June 7, 2011

RE: PLUS review - 2011-04-04; Bayside Mini-storage

My client is seeking a rezoning from AR to CR-1 with limited traffic for a 29,400 sq. ft. mini-storage facility. State agency comments are duplicated below in black ink using this font. *Developer reponses are duplicated below in blue ink using this italicized font.*

Figure1: SWMP mapping in the immediate vicinity of the proposed project

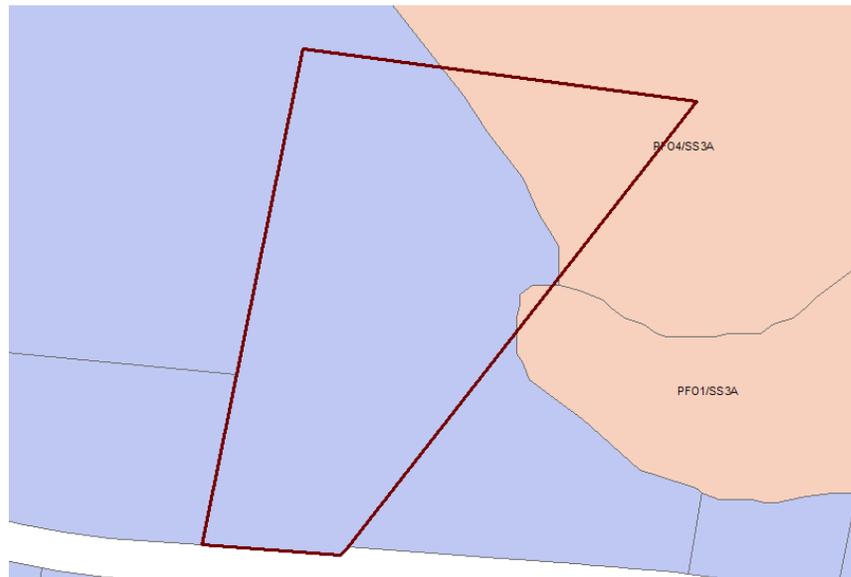
- According to the Statewide Wetland Mapping Project (SWMP) maps, palustrine wetlands (PF04/SS3A & PF01/SS3A) were mapped in the area proposed for development (See Figure 1).

*Environmental Resources, Inc. was retained to complete a delineation of regulatory wetlands on the project site. The delineation has been completed, and is indicated on the plan. The site is not anticipated to have any wetland impacts, except perhaps rip-rap for the pond outfall, which can be permitted under a Nationwide Permit, if necessary.*
